### Poulsbo Place Division 8 | Site Plan Review and Redevelopment Master Plan Amendment | Type III

**To:** City of Poulsbo Planning Commission  
**From:** Marla S. Powers, Associate Planner  
**Date:** February 16, 2021  
**Subject:** Poulsbo Place Division 8 Site Plan Review and Redevelopment Master Plan Amendment

### PLANNING FILE P-03-24-20-01

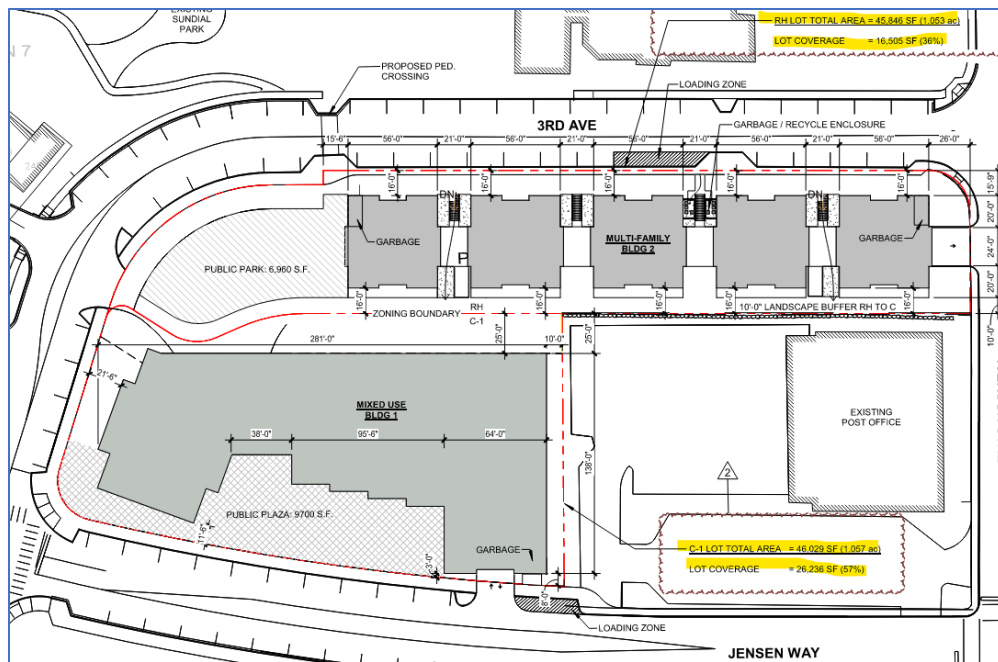
*Staff Comment:* The request to increase the lot coverage from 50% to 60% is supported by staff. This specific amendment request discusses looking at the project as a whole, and that as a whole the proposal would have an average lot coverage of 50%, which would meet both the PPRMP commercial and residential standards. Independently, the commercial lot coverage proposed as 60% meets the current zoning lot coverage of 85%. The residential lot coverage proposed as 40% is well below the current zoning standard of 60%. The amendment, as requested, would be the new standard to which approve this project. Staff concurs with this request.

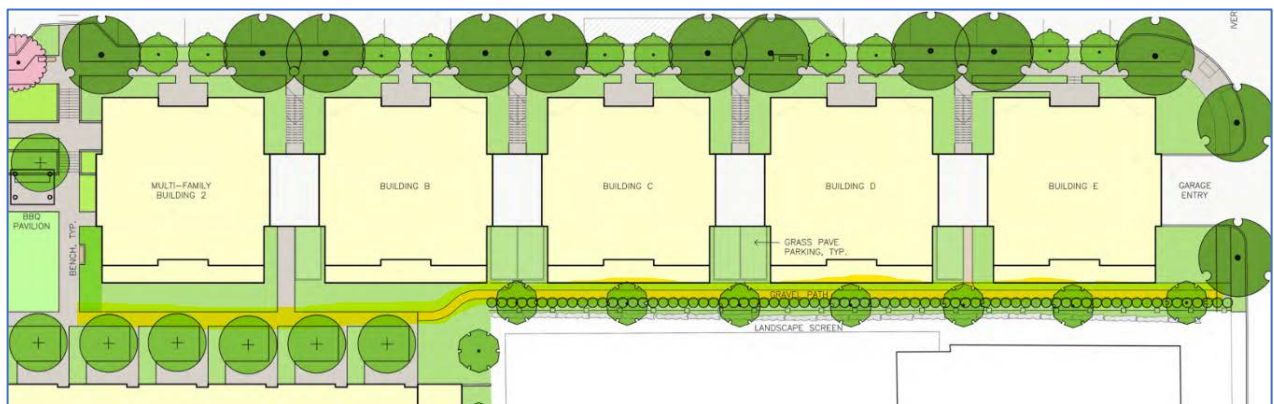
*Staff Comment:* Page 31 of the PPRMP states that although the PPRMP does not have specific setback requirements, minimum setbacks are invoked through the landscape ordinance and parking requirements. For the R-D and R-DH Zone Districts in the PPRMP the rear yard setbacks were reduced from the 1994 Zoning Ordinance. This request is to reduce the rear yard setback in the PPRMP from 15' to 10'. The current code requirement for a rear yard setback in the RH zone is 10'. This request, therefore, would make this proposal consistent with the current code as well. This request appears reasonable and matches the alternative landscaping request for 10' in the response to Item #5 above. The proposal has taken care to develop the site with underbuilding parking so as to reduce the negative impact a large parking lot would have on the immediate surrounding areas. The underbuilding parking does require at least 64' of width (20' x 2 for parking on two sides and a 24' access drive for vehicles). The site is approximately 90' wide. With the front

yard setback of 15', this leaves the proposal with the ability to meet a 10' rear yard setback. Staff concurs with this request.

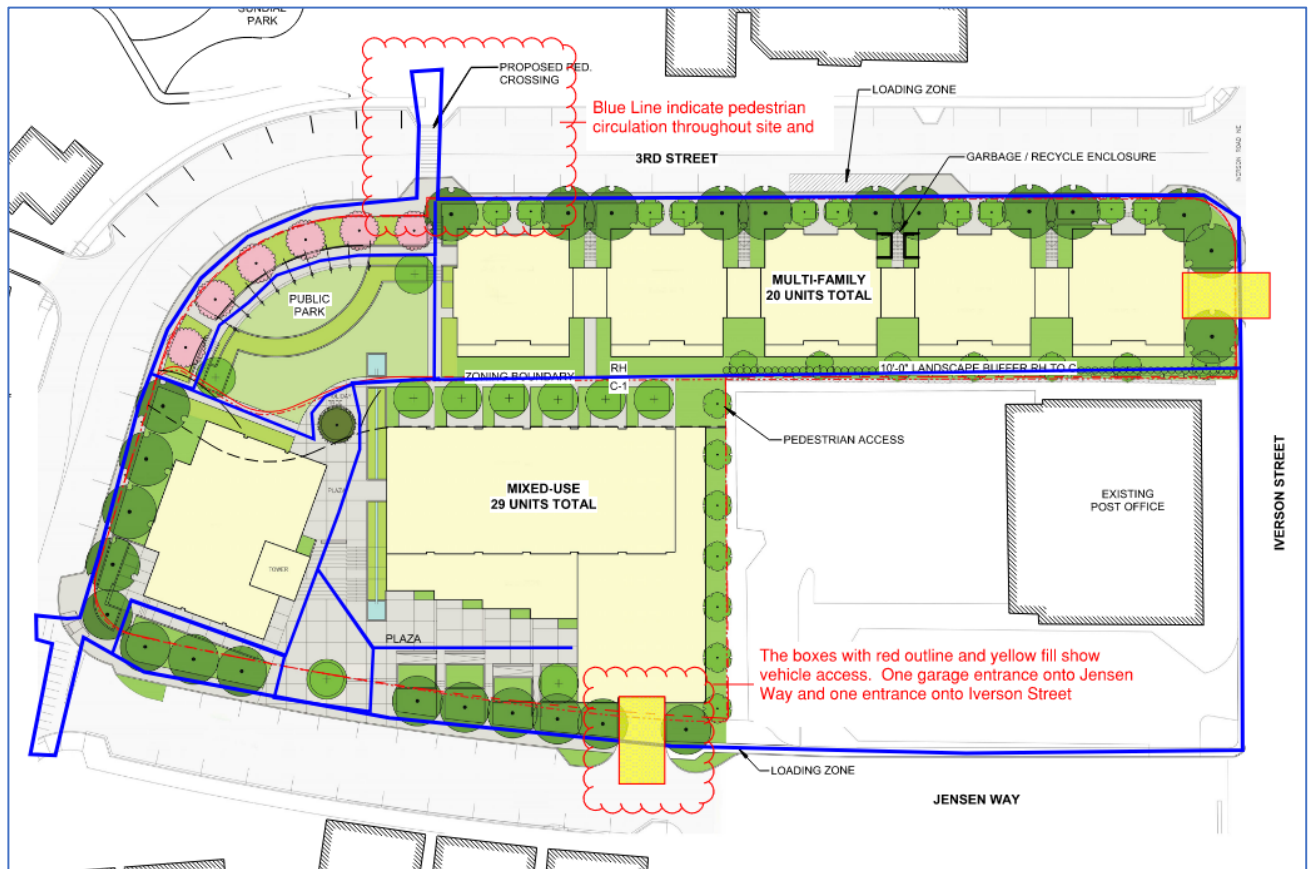
*Staff Comment*: The pedestrian circulation is shown in the image below with the blue lines and the vehicular access to the site is shown with the yellow box. This provision is met.

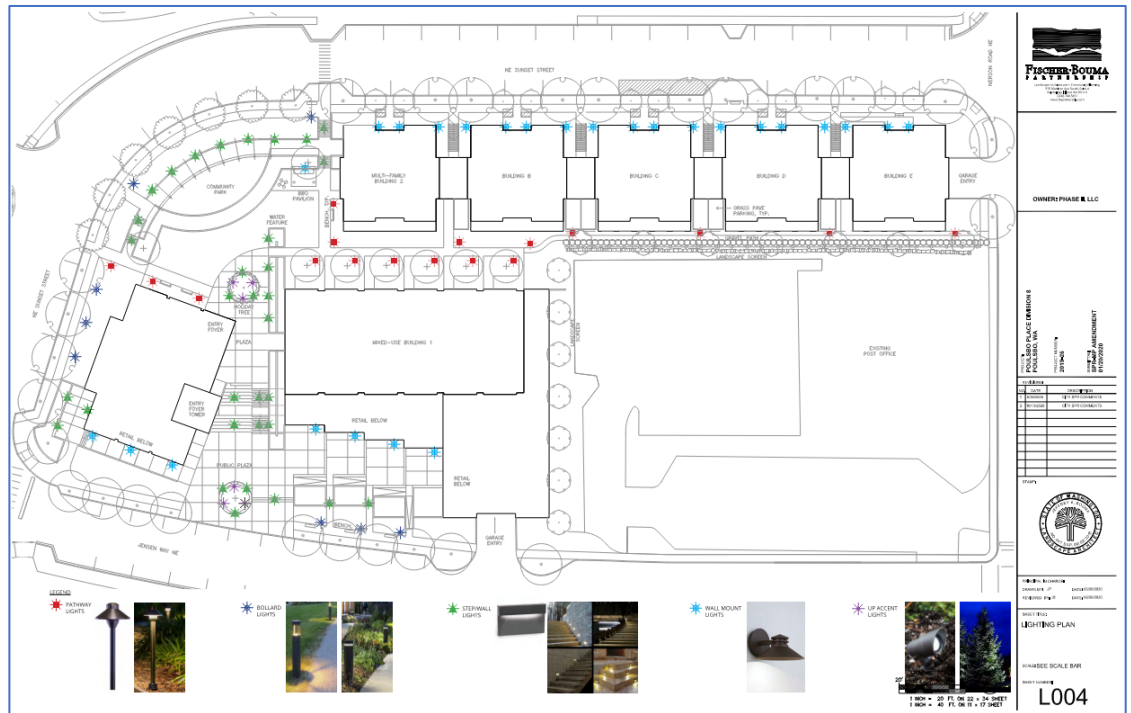
Landscape buffers east of the site are provided with a 25-foot setback and landscape area and meet and exceed the Type I landscape buffer requirement. See Sheet L001 to the right highlighting both landscape buffers. Sheet A 25 shows a rendering of the Type I landscape buffer. Landscape buffers south of the site area provided in a 10' wide planting area that exceeds the size requirement, see Sheet L001. The landscape buffer criteria, including the request for use of the Alternative-Type I Landscape Buffer discussed in the staff report above on page 13 and the reduced rear yard setback discussed in the staff report on page 13 are met.

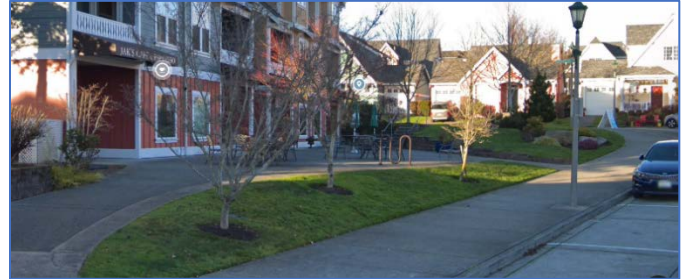
*Staff Comment:* Details for paving on sidewalks has not been shown. Parking pockets and landscaping between the street and the sidewalk are shown and include street trees. See Sheet L001 for these details. A Condition of Approval will be required to ensure this proposal meets the detailed paving on sidewalks criteria. These streetscape improvements can be shown as part of the Final Landscape Plan, or the street lighting could be integrated into the Lighting Plan. The Condition of Approval will require streetscape improvements similar to those currently constructed on Front Street, to the satisfaction of the Director and the City Engineer, as part of the Final Landscape Plan. These shall include enhanced paving on sidewalks, parking pocket, and landscaping. They would be similar in context to the existing improvements along Front Street and Jensen Way shown respectively below.

Sheet A 29 provides colors and materials as a general palette for the proposal and is provided here.

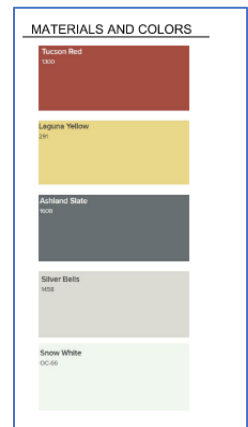
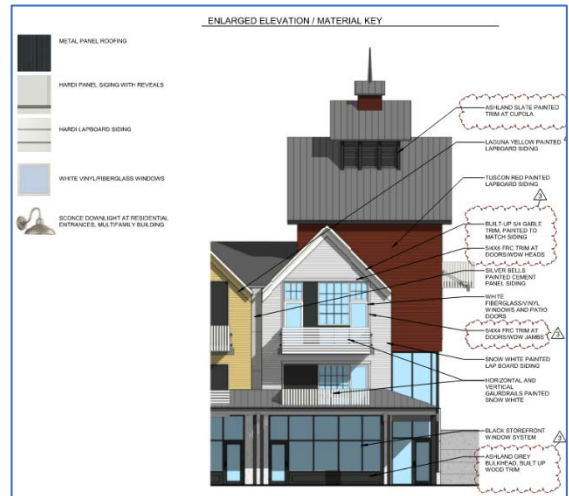
**Staff Comment:** The color palette is provided in Sheet A 29 and shows the following colors (also provided here): Tucson Red (1300), Laguna Yellow (291), Ashland Slate (1608), Silver Bells (1458), and Snow White (OC-66). In the discussion in Item #c above, it appears that these colors are similar to those across the street. The color criterion is met.

Sheet A 15 (west elevation)

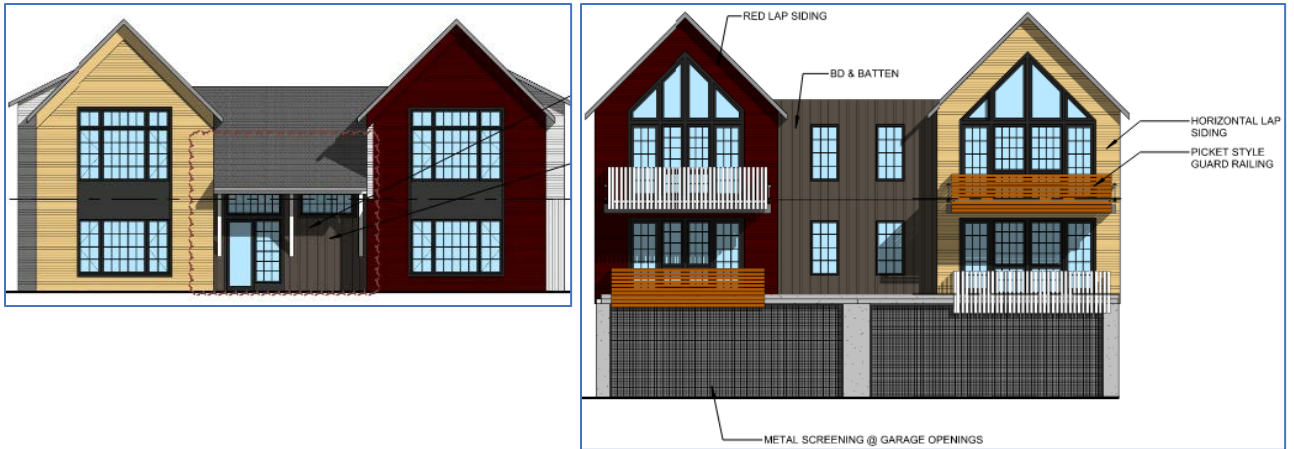
Multi-Family Elevations Sheet A 15 and A 16 show(respectively shown in images below) the visual interest provided on the front and rear elevations that include balconies, porches, window detail, building material, and architectural design.

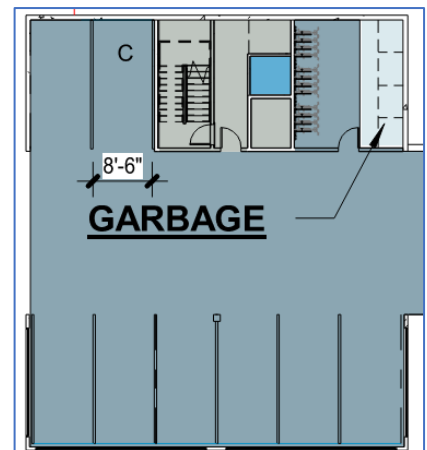
Staff Comment: Open space is requested to be reduced to 15% for the multi-family open space requirements. The open space reduction is addressed in Section III, Criteria 5, Item #7. The public park is located in a corner of the site that is sheltered by the adjacent multi-family building and mixed-use building and built into the topography at the corner of 3<sup>rd</sup> Avenue/Sunset Street with street trees. The noise and traffic impacts are expected to be reduced due to this location, topography change, and landscaping. Birdseye @ Community Park Sheet A 25 provided below shows a rendering of this space.

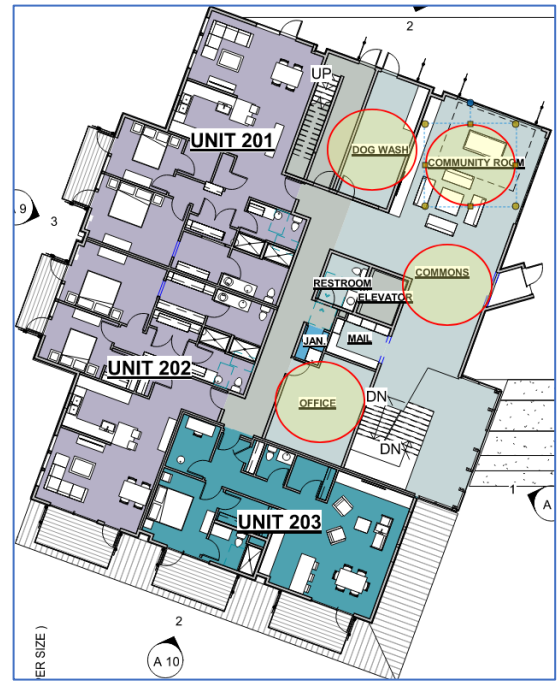
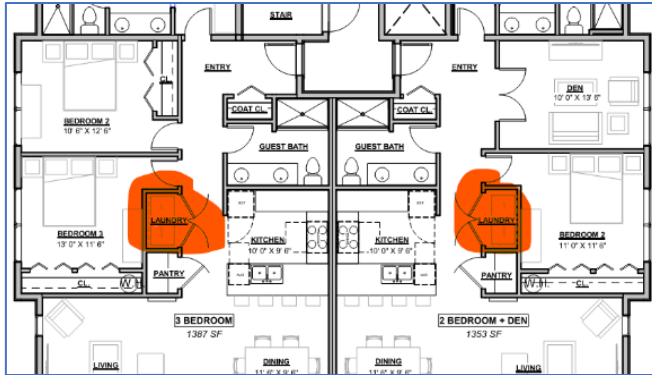
**Staff Comment:** The building plans from Multi-Family Floor Plan Sheet A 13 shows laundry is included in each unit. The laundry is highlighted in red in the image. Other auxiliary facilities such as the sales/lease offices, community room and commons area are provided in the mixed-use building for both the commercial and multi-family proposals. This is shown in Mixed-Use Floor Plan Sheet A 6 with image shown below with these items highlighted in yellow circles. This criterion is met.

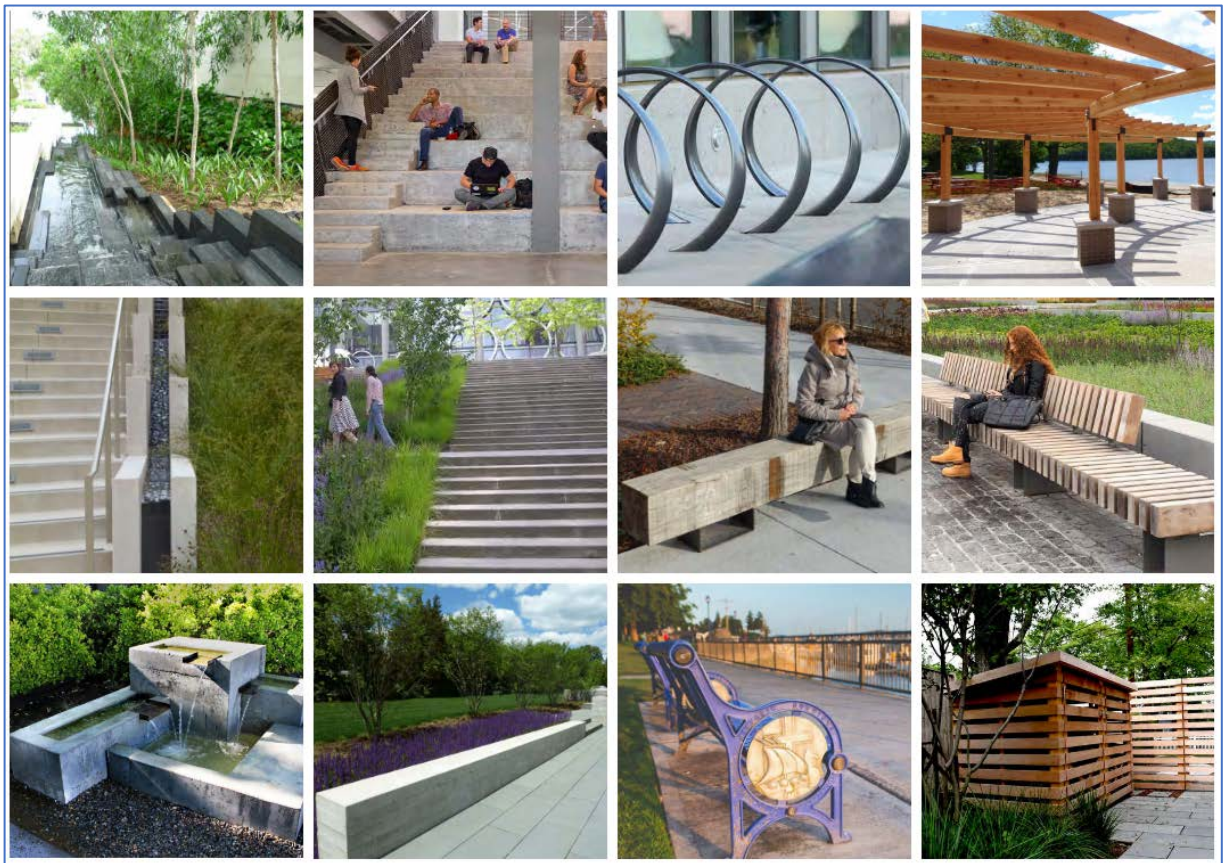
Staff Comments: Street furniture intention has been provided as part of the proposal. See Site Elements Sheet L003 and as provided below for design ideas. Staff supports the street furniture palette as provided in the application. A Condition of Approval will be to submit plans for street furniture including information regarding type, placement, installation, and maintenance to the City for review with Final Landscape Plan submittal. As conditioned, this criterion is met.

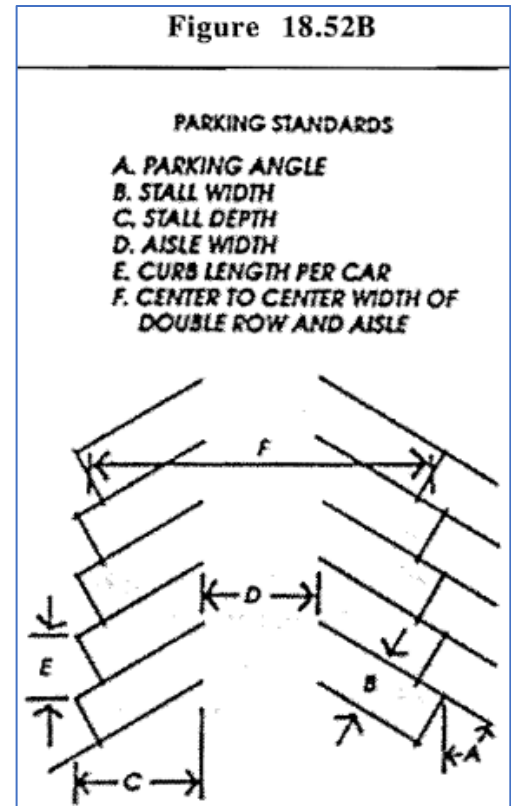
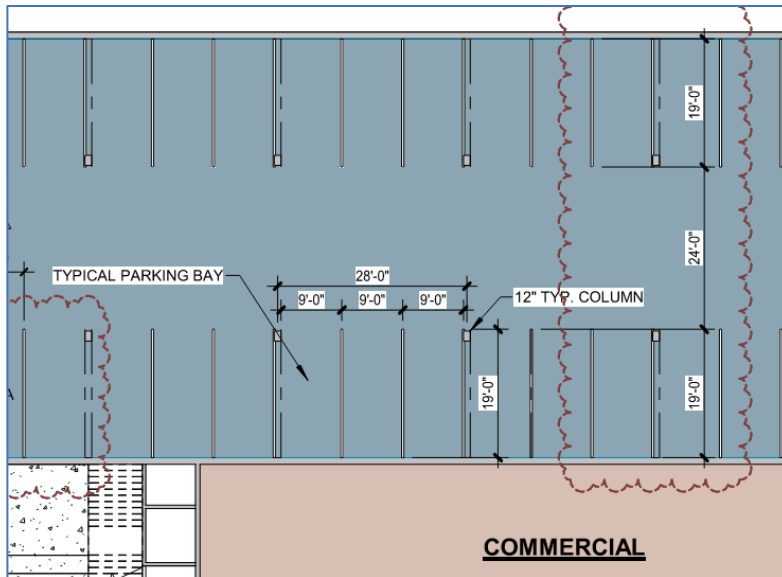
**Staff Comment:** The parking dimensions meet these standards. Multi-Family Garage Plan Sheet A 12 and Mixed-Use Garage Plan Sheet A 5 show the parking standards. This criterion is met.
